FIELD CHANGE ORDER

PAGE 1	OF 1
RE ECN NO.	17-014

MANUFACTURING EFFECTUATION DSC801/39,40,43 and upwards.	EQUIPMENT AFFECTED RC 8000 RC 8200 / DSC 801 Disc Storage Controller.
NOTE

Correction of Bus-out parity during write operations.

Position 71 :

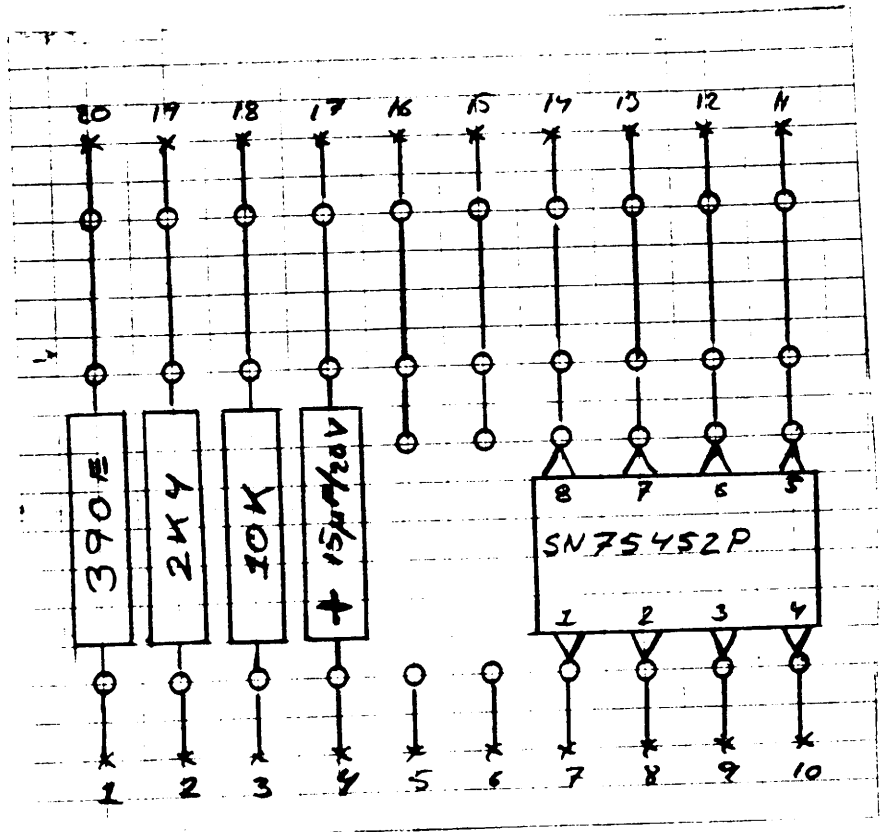
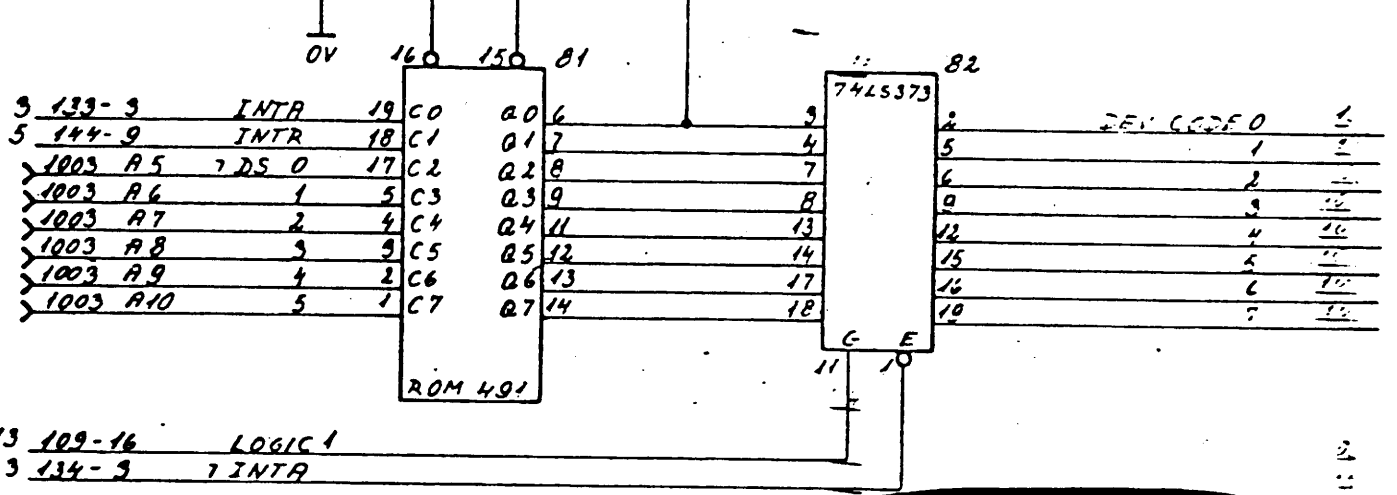
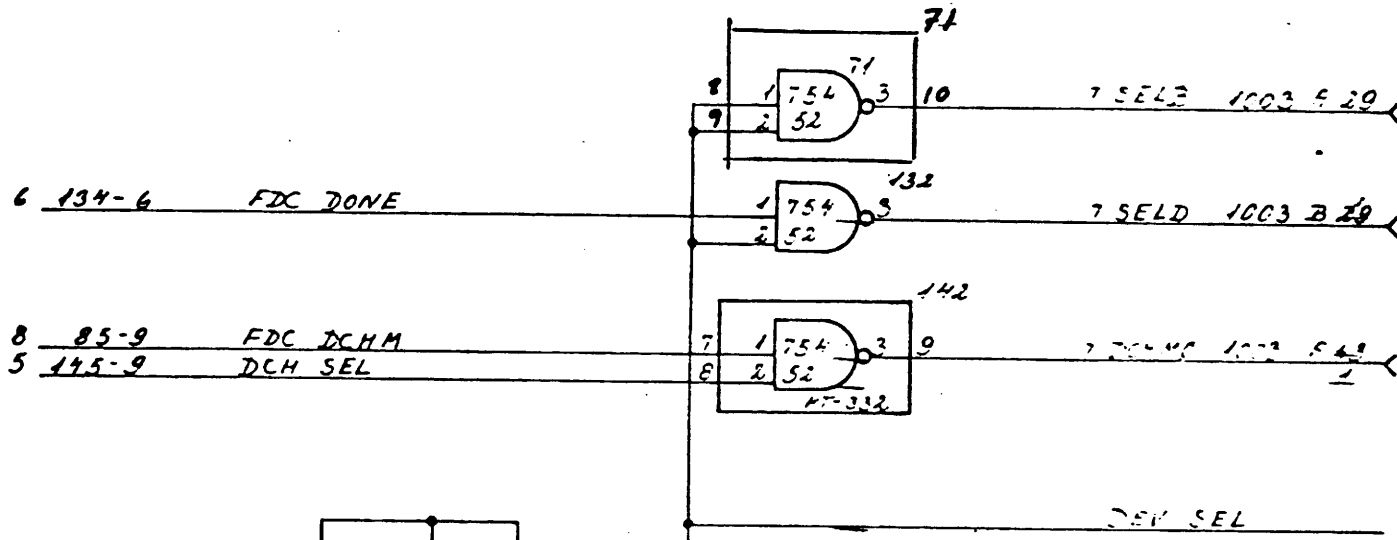
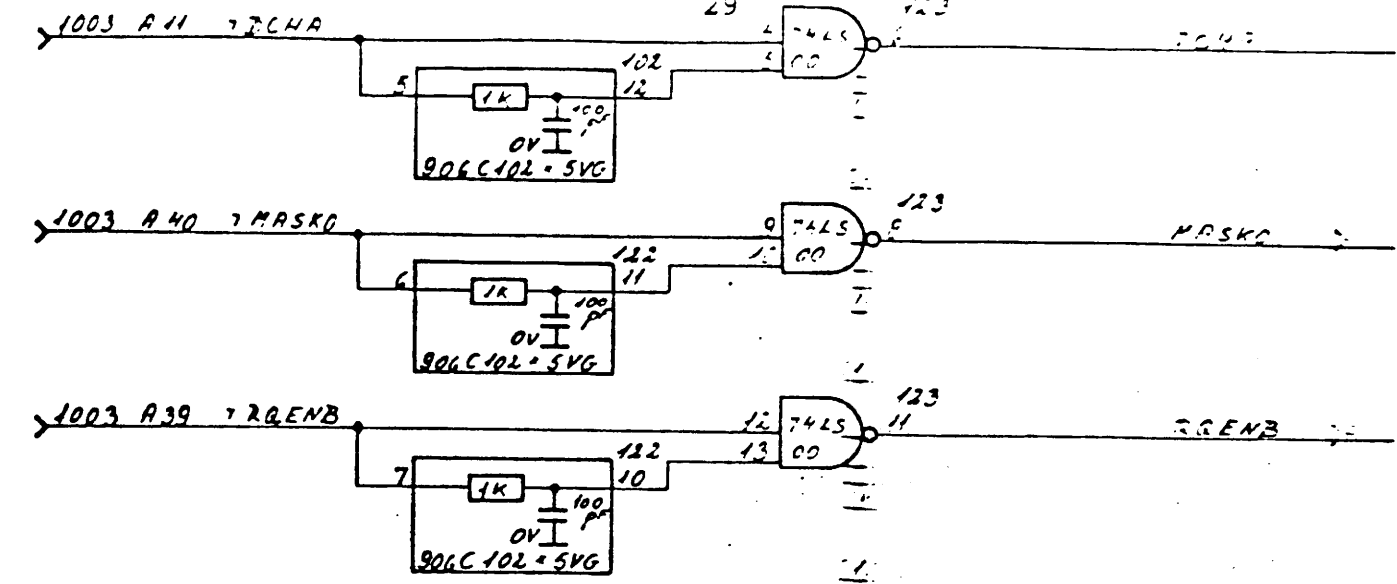
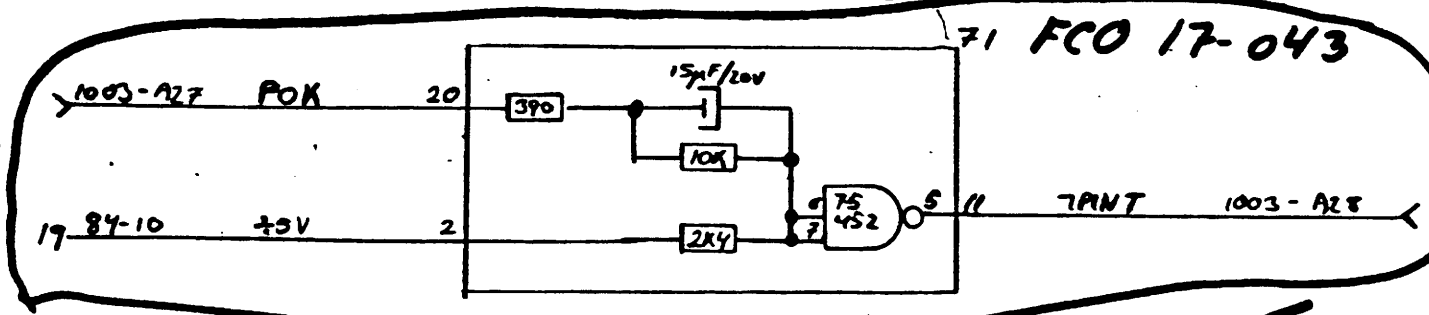
REASON FOR CHANGE
On the FDC 705 the Bussignal >PINT is used to reset the two Floppy Disc Controller Chips (FCO 17-042). However, in some systems the >PINT signal is deactivated before the on board generated -5V and +12V voltages are stable. In these systems the chips may not be reset, and Dead-Lock may occur.

ADDITIONAL COMMENTS
This change provides a -5V voltage-monitoring, to secure that the >PINT signal is active at least 10msec. after the -5V is stable. In case of errors (-5V missing) the >PINT will not be released and the whole system will be inoperable.

- Mount the components in position 71 according to the assembly drawing on page 2.
- Add the following wires :
(1003-A27) → (71-20)
(1003-A28) → (71-11)
(71-1) → (71-3) → (71-4)
(71-12) → (71-13) → (71-17) → (71-18) → (71-19)
(83-2) → (71-2)
- Code the FCO-Label 17-043

3 pages of provisional flow chart.
4 pages of provisional microprogram-list

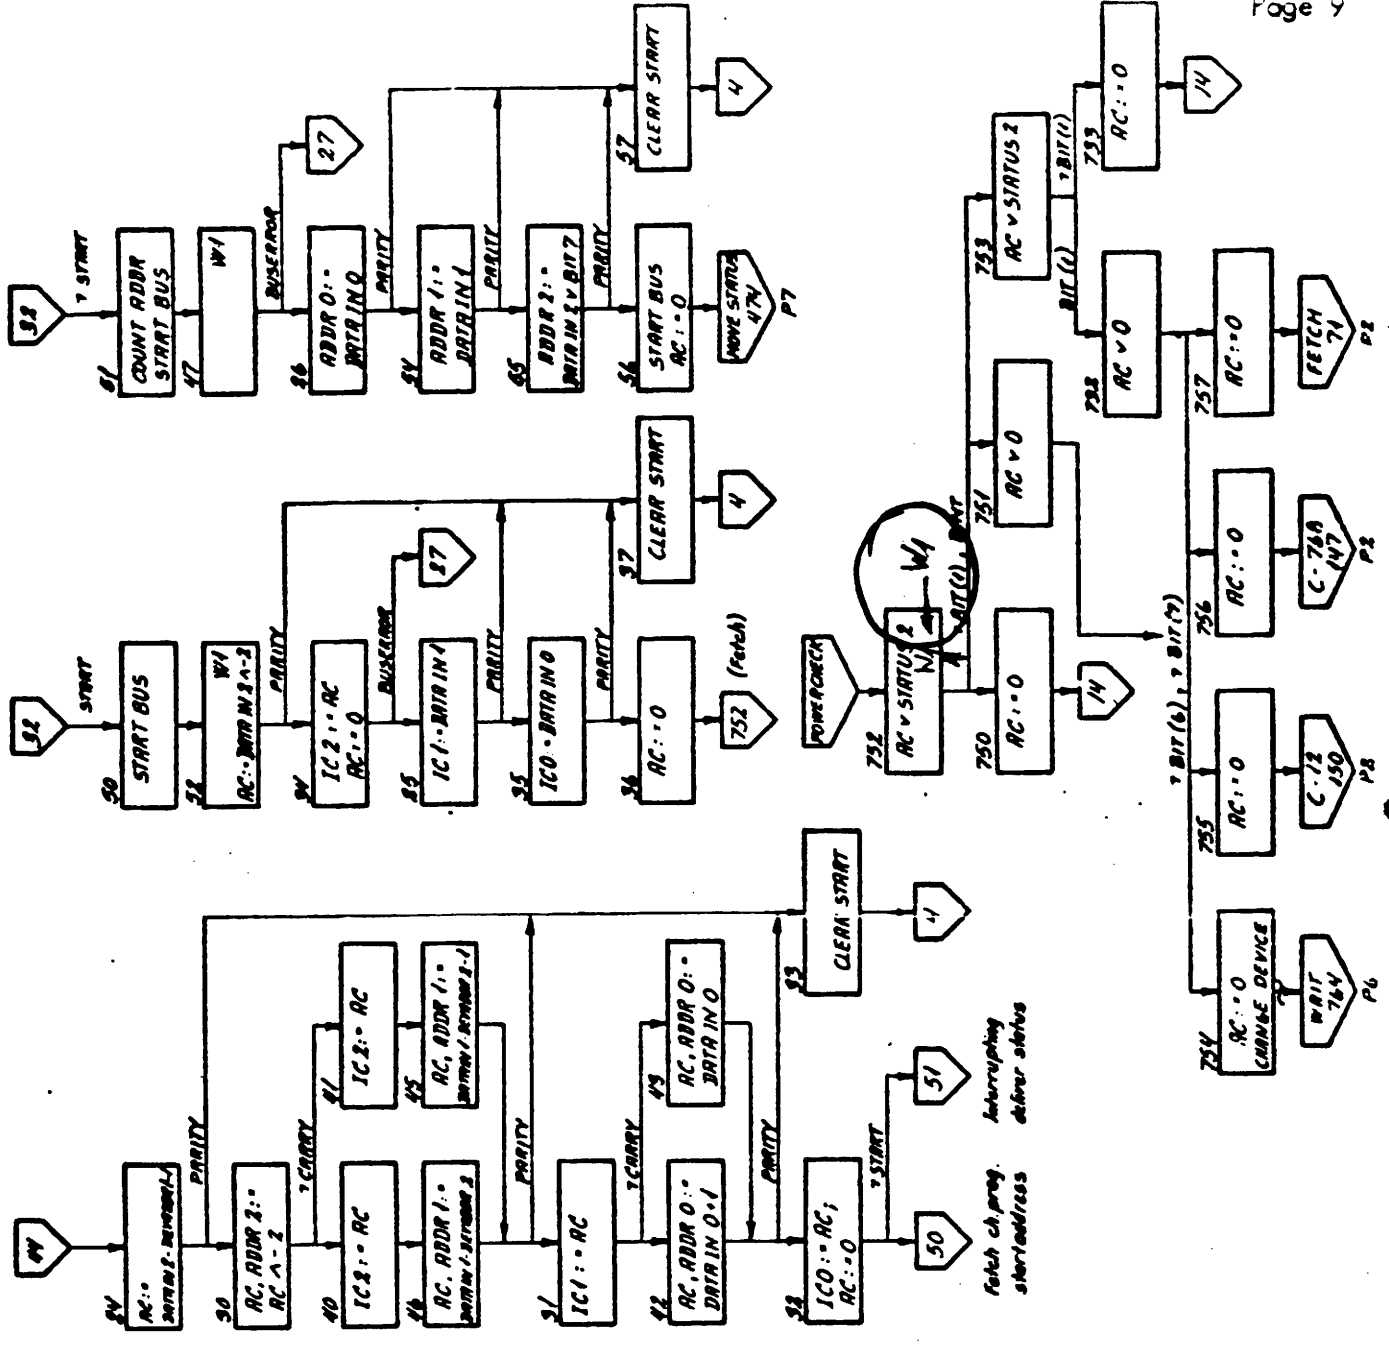
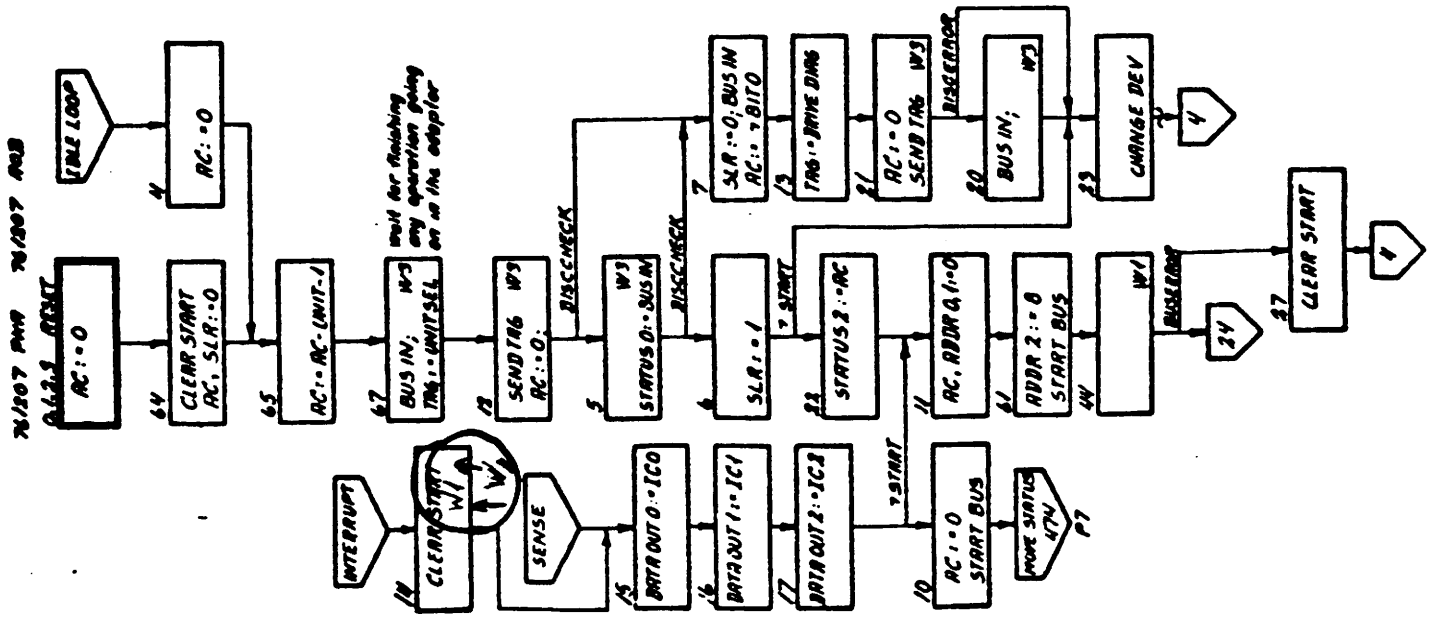
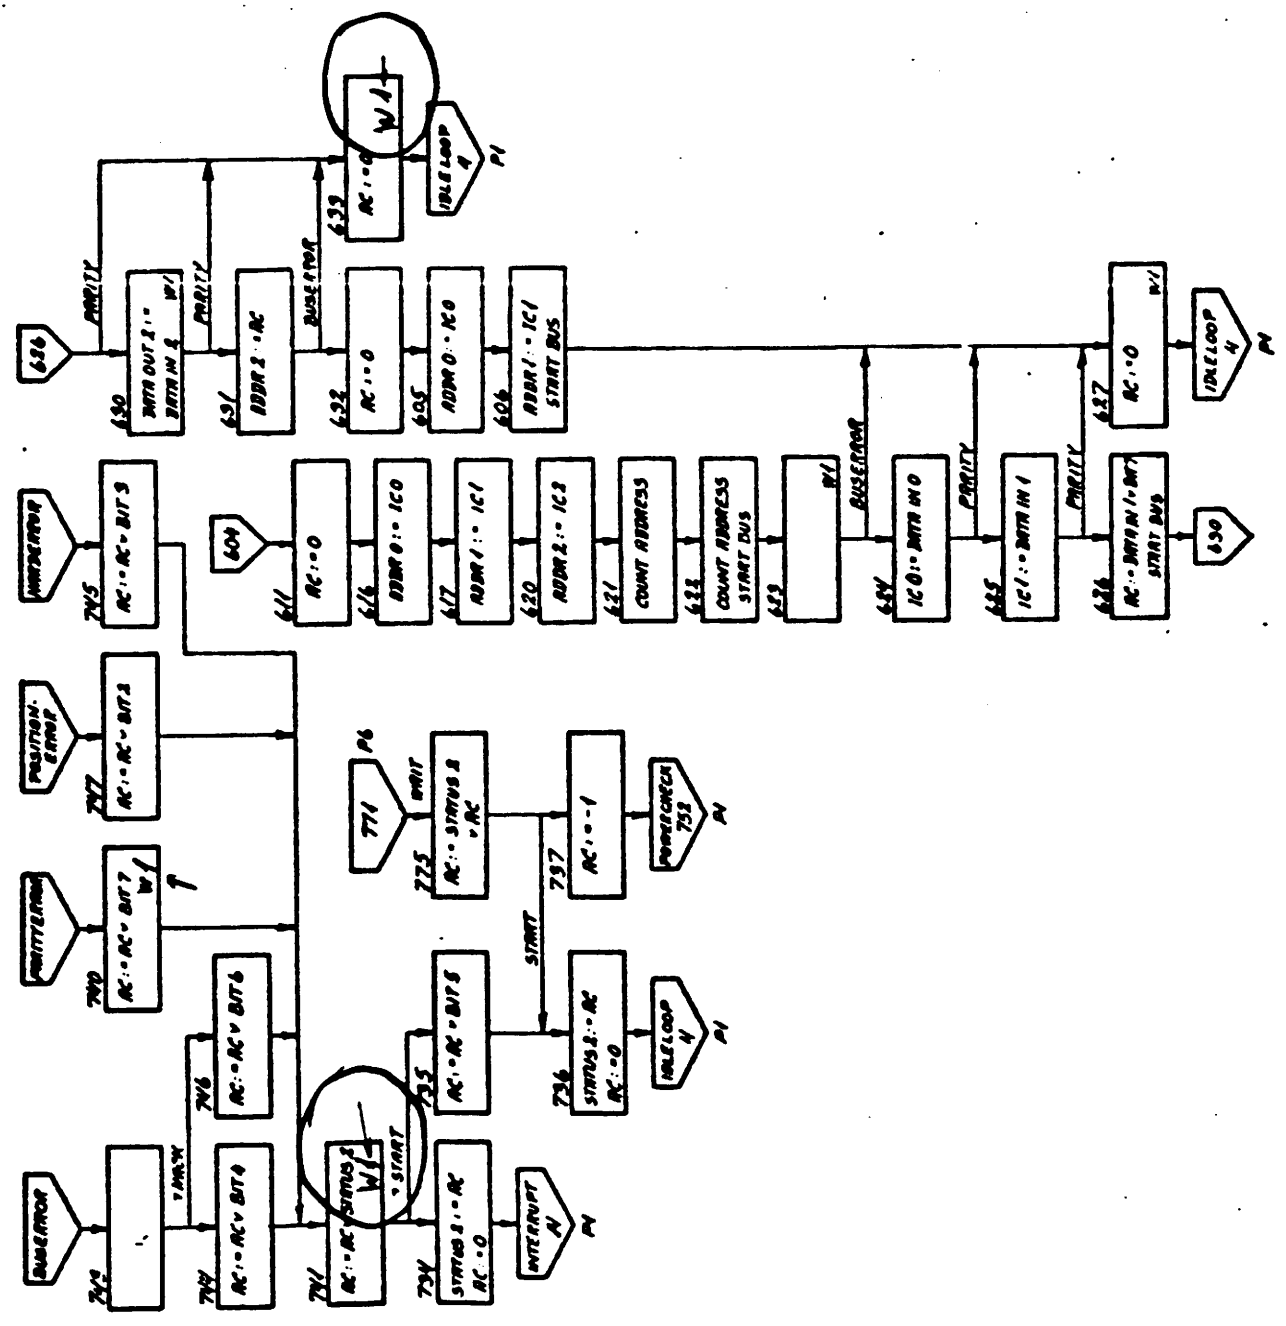
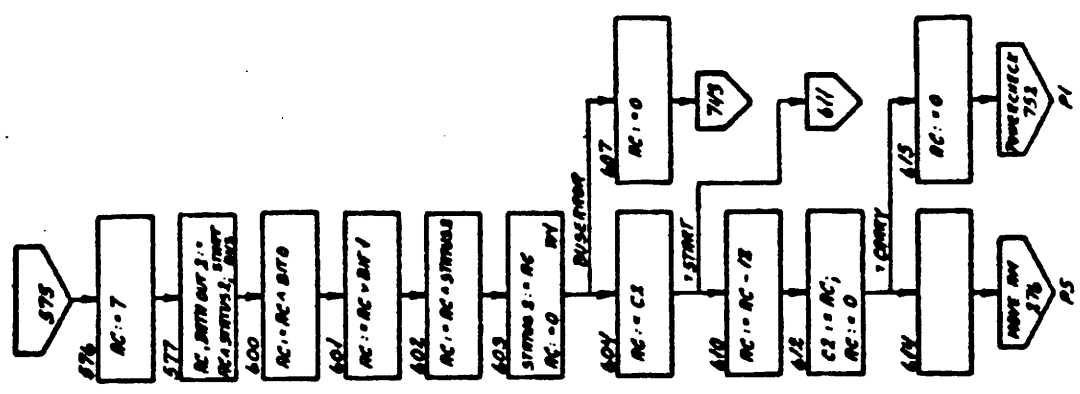
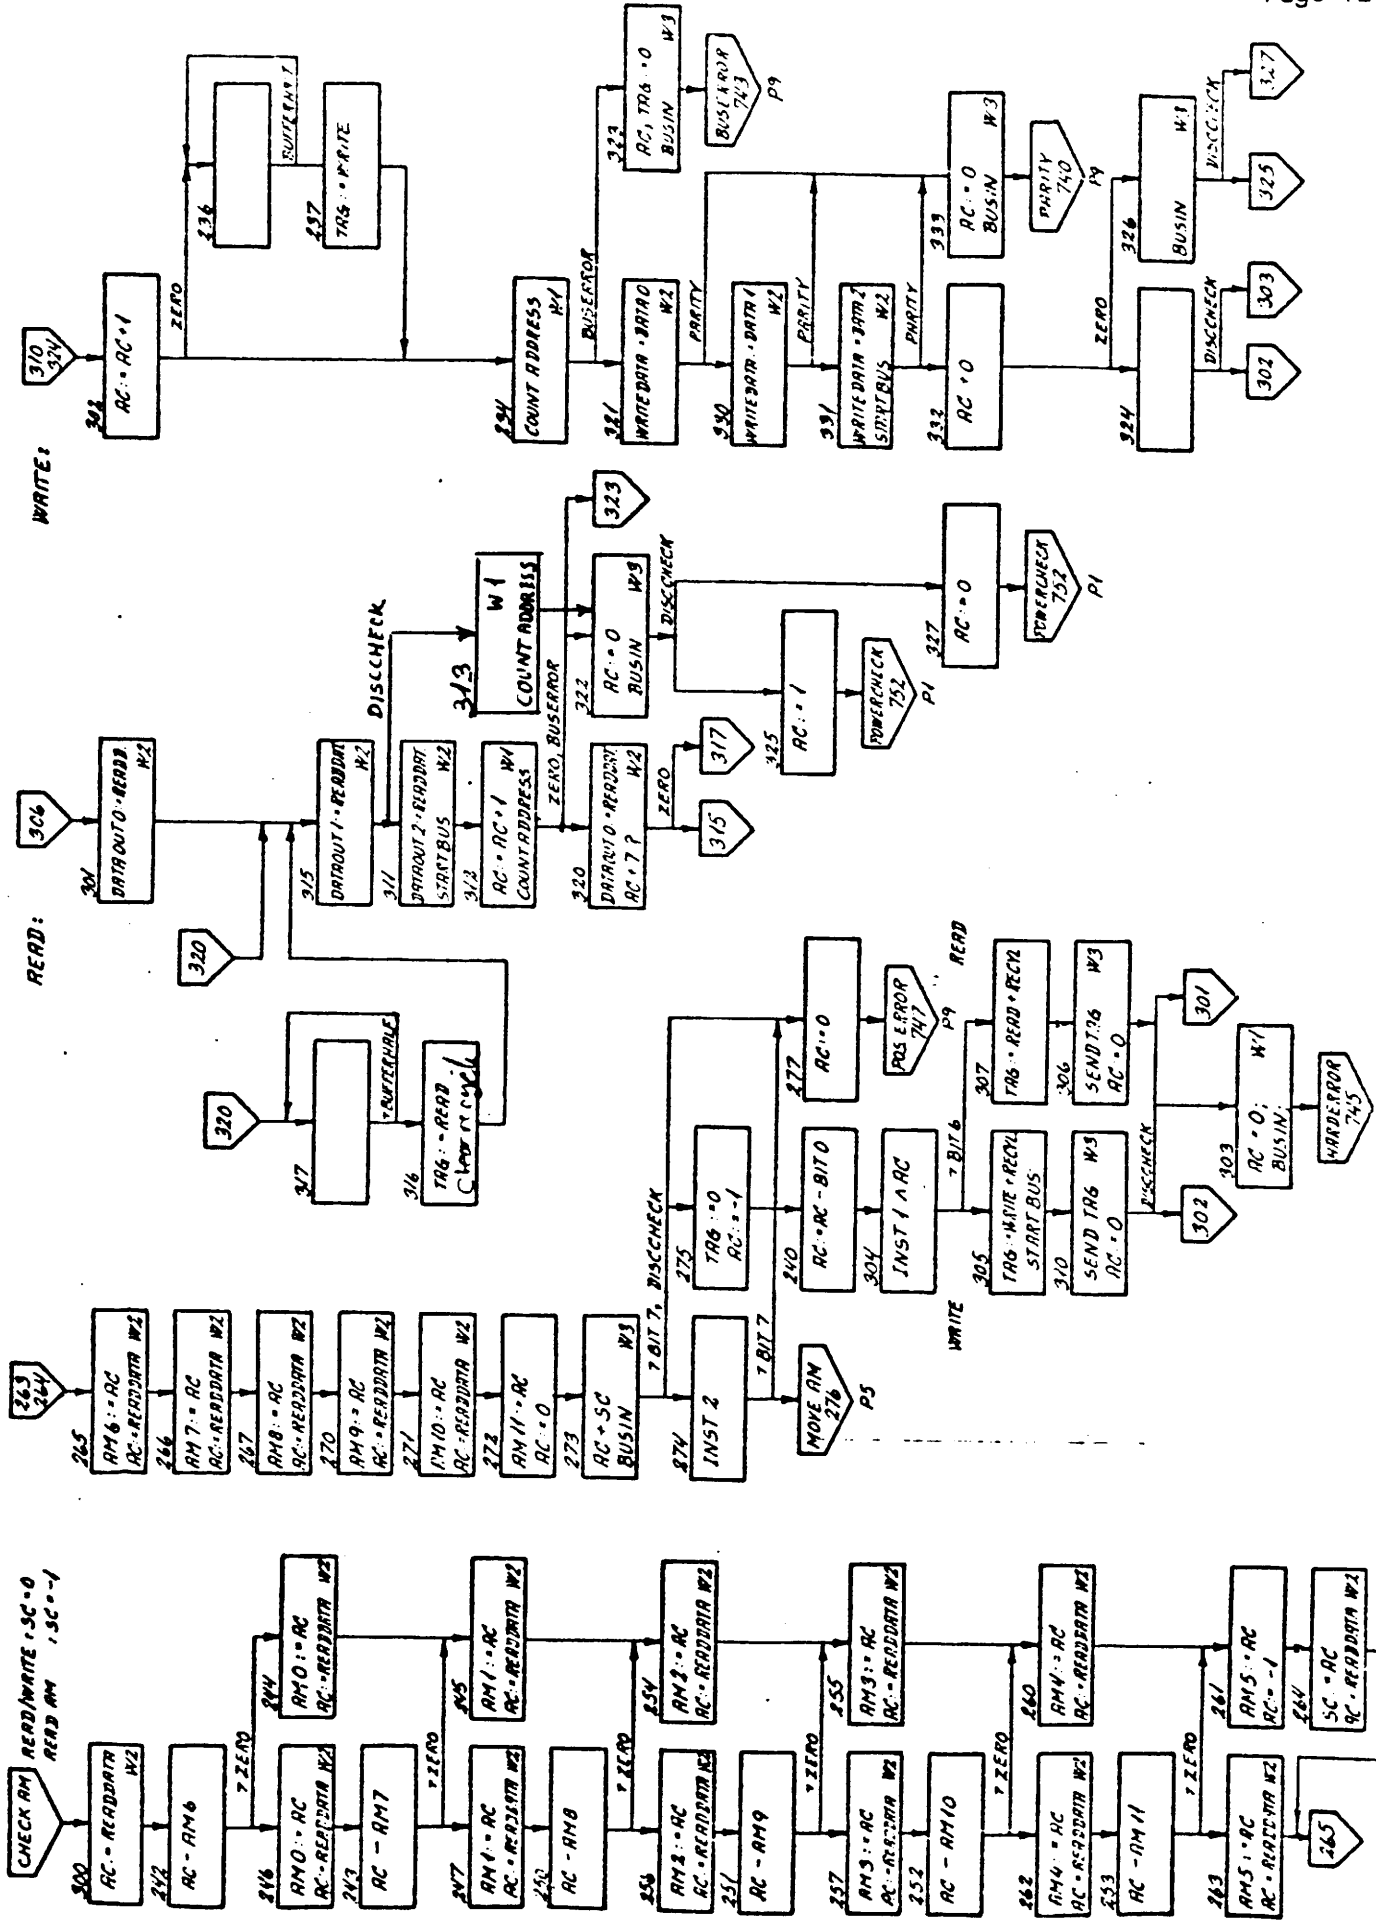
- To correct a microprogramm error in DSC 801, which under severe busload conditions may cause improper busoperation with busparity as possible result.
- To avoid microprogram hang up and subsequent system hang up, after attempts to read uninitialized discpacks.

Replace ROM 167 in pos. 40 by ROB 364

- ROM 163 - - 38 - ROB 365
- ROM 164 - - 28 - ROB 366
- ROM 165 - - 80 - ROB 367
